**ITEM E8 - Timber Hills Subdivision 2022 Replat**

**KPB 2022-007**  
**S11 T07N R12W**  
**Nikiski**

<b>KPB File No.</b>	2022-007
<b>Plat Committee Meeting:</b>	March 21, 2022
<b>Applicant / Owner:</b>	Michael B. Brunke, Nikiski George F. Brown, Nikiski
<b>Surveyor:</b>	John Segesser / Segesser Surveys
<b>General Location:</b>	Nikiski

**STAFF REPORT**

PRELIMINARY PLAT

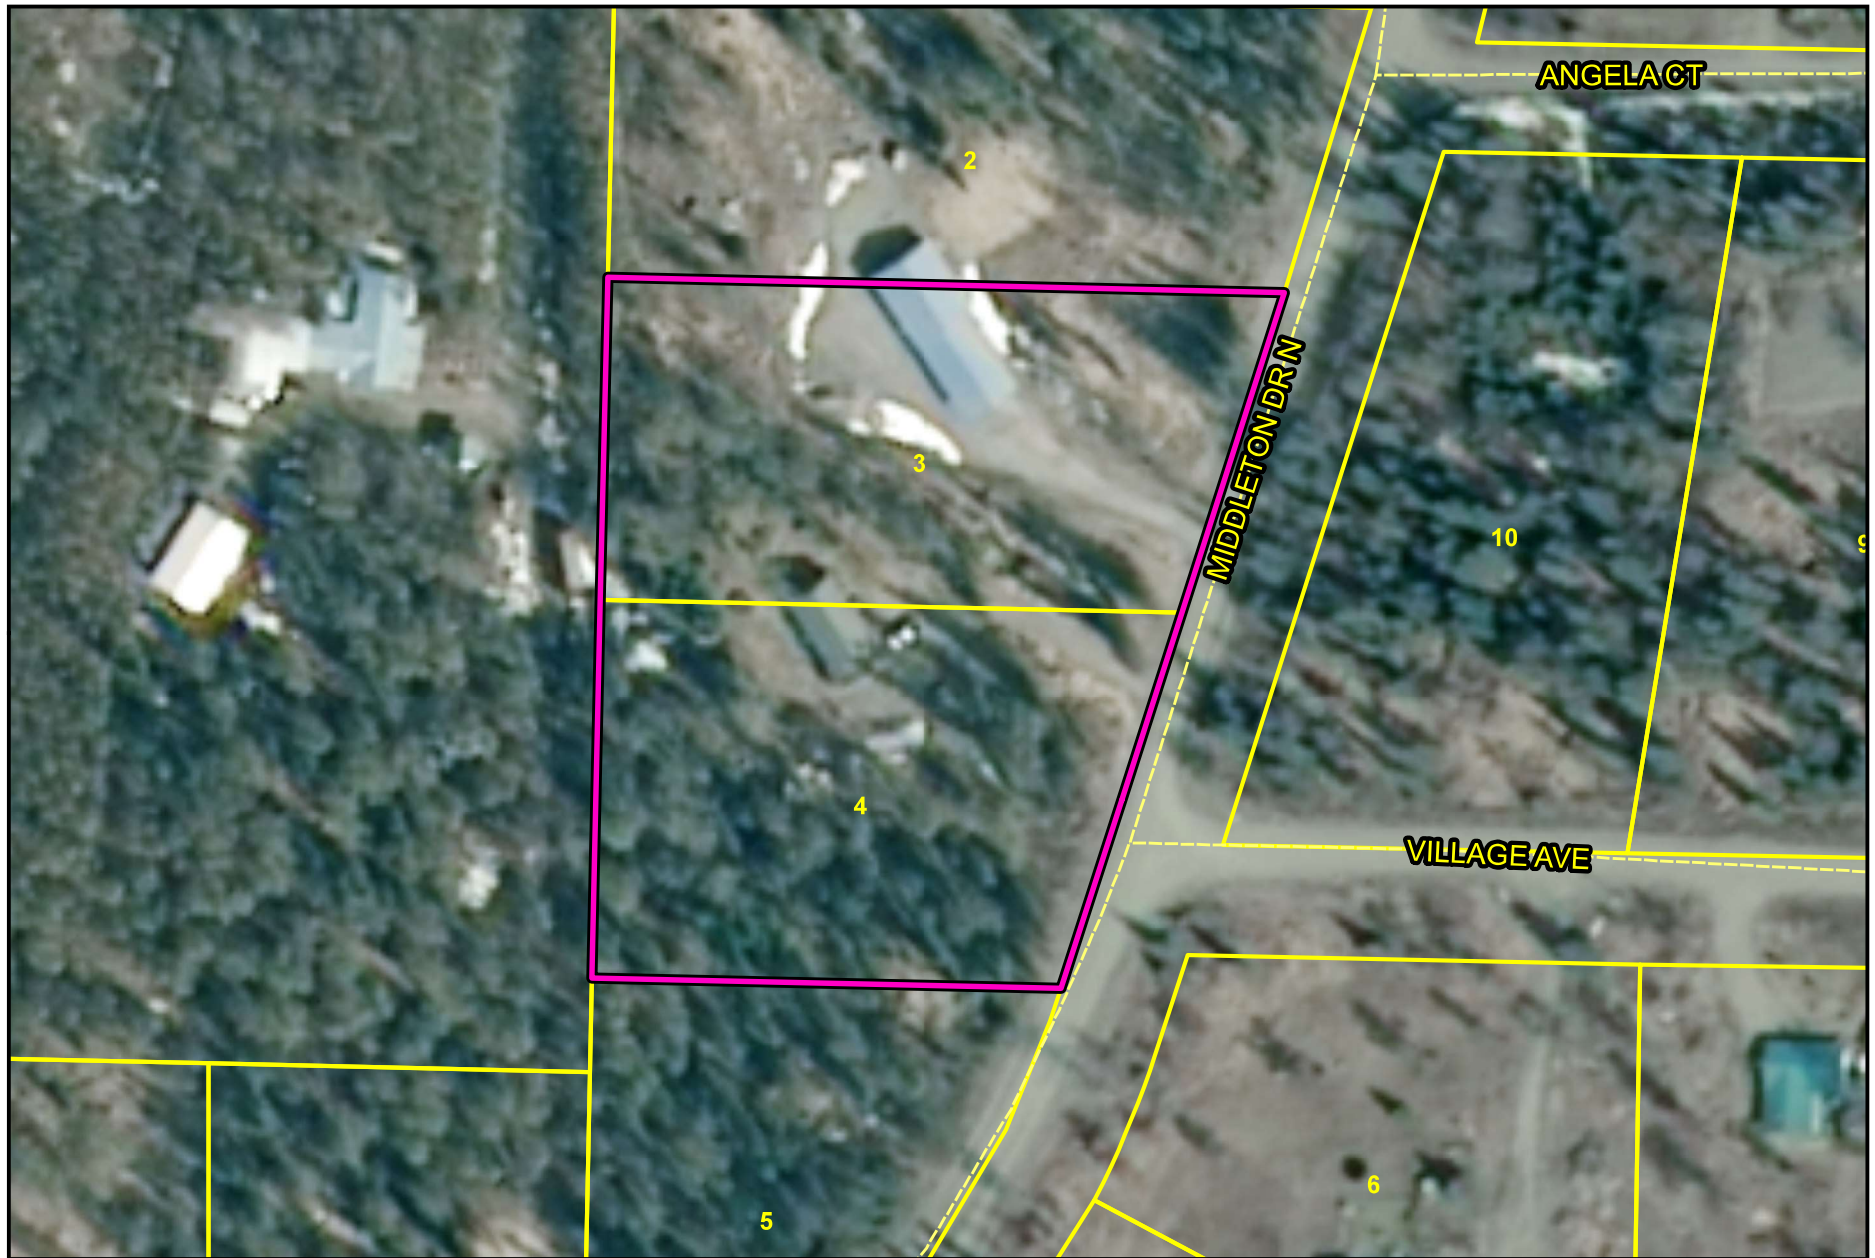
**Staff recommendation:** *Correct the aliquot part location to NW1/4 NE1/4 Section 11, T7N, R12W, S.M.*

**Staff recommendation:** *Provide the location of the subdivision within the Vicinity Map.*
- N. Apparent encroachments, with a statement indicating how the encroachments will be resolved prior to final plat approval;

**Staff recommendation:** *This platting action will resolve an encroachment of a building on the boundary of Lot 3 and Lot 4. Another structure appears to be located over the boundary of Lot 2 and proposed Lot 3A. Cuncur that as both Lots 2 and proposed Lot 3A are under common ownership that an encroachment does not exist at this time on the north boundary of this subdivision. Staff cautions the land owner that any transfer of title of either Lot 2 or Lot 3A may create an encroachment issue.*

**Staff recommendation:** *The parcel to the west is a large acreage parcel that can be further subdivided. Provide a 60 foot right of way dedication to provide for the continuation of Village Avenue to the surrounding tract to the west.*

**Staff recommendation:** *A right of way dedication for the extension of Village Avenue must be 60 feet wide as the neighboring parcel is unlikely to be subdivided and cannot provide a matching right of way dedication.*

**Staff recommendation:** *Concur that a 60 foot right of way dedication on the south boundary will generally align with Village Avenue as the width of the opposing right of ways will have an area that overlaps.*

**Staff recommendation:** *The block length along Middleton Drive North is 2,663 feet long and longer than the allowable length of 1,320 feet. A right of way dedication for the extension of Village Avenue will help to comply with block length by allowing the 10 acre parcel to the west to extend the right of way when it is further subdivide.*

**Platting Staff Comments:** *A soils report was not prepared for the parent plat. Per KPB 20.40.020 a soils analysis report will be required.*
